QUESTIONS AND ANSWERS

IFB 06072022LB PARKWAY VILLAGE ES ACTIVITY FIELD

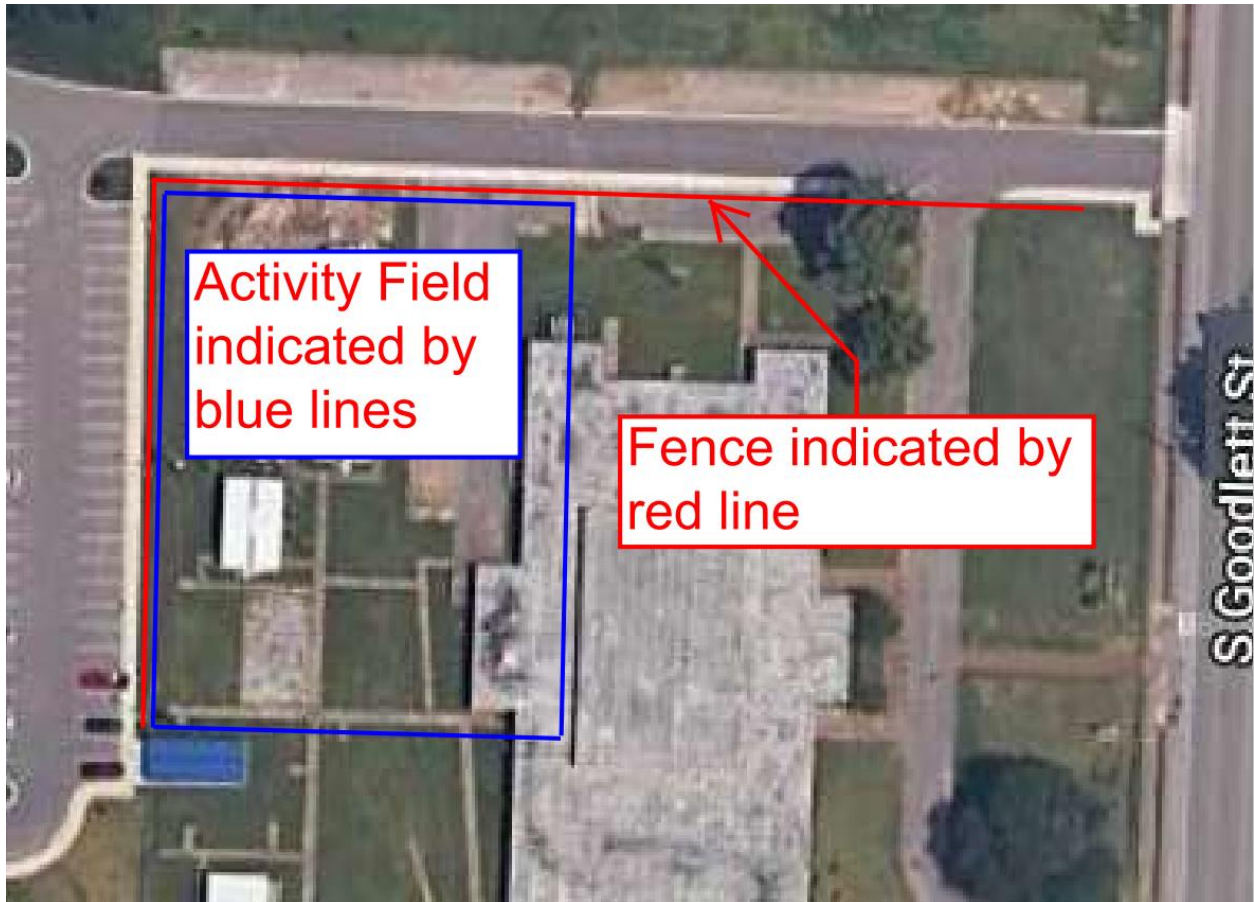
- 10. Can you include a marked up drawing of the work area(s)? A simple screenshot of Google maps will suffice.**
 - a. Yes. Provided below.
